**BATHROOMS AND RAMPS  
VETERANS AFFAIRS CAMPUS – BUILDINGS 2, 3 & 4  
ROCKY HILL, CONNECTICUT 06067  
PROJECT: BI-C-275**

<b>BID OPENING</b>	<b>1:00 P.M.</b>	<b>FEBRUARY 17, 2010</b>
<b>ADDENDUM NUMBER 1</b>	<b>DATE OF ADDENDUM</b>	<b>JANUARY 13, 2010</b>

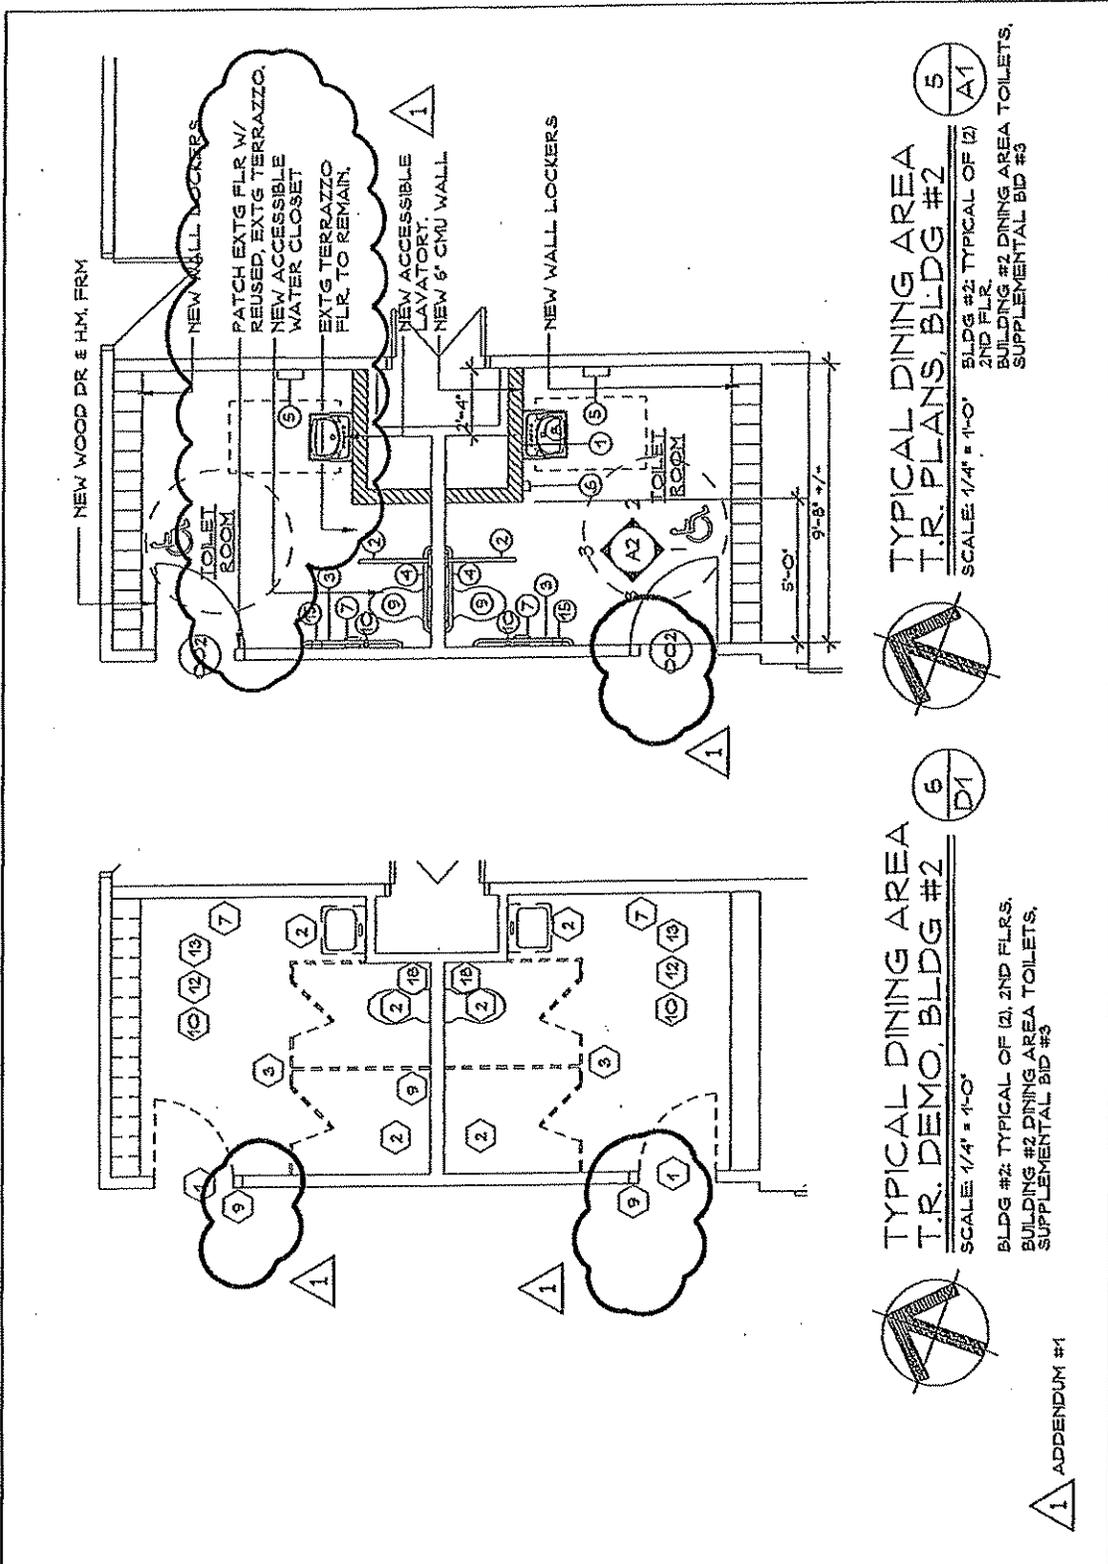
### Information Required on the Following Issue:

- 1) WOOD DOOR SPECIFICATION 081416, PAGE 3, PARA. 2.5 - B CALLS FOR A MINIMUM STC SOUND RATING OF STC-35. *STICK W/ SPECIFIED STC - 35*
- 2) BASED ON AN APROX. QUANTITY OF 29 DOORS FOR THIS PROJECT, THIS SOUND RATING WOULD ADD APROX. \$15,300.00 COMPARED TO STANDARD PARTICLE CORE DOORS.
- 3) DOUBLE LAYER ACCOUSTIC GLASS IS INCLUDED IN THIS ADD PRICE COMPARED TO STANDARD 1/4" TEMPERED GLASS SHOWN ON SHEET A1 DOOR ELEVATION TYPE-1. *STICK W/ SPECIFIED GLAZING PER CDS / SPECS.*
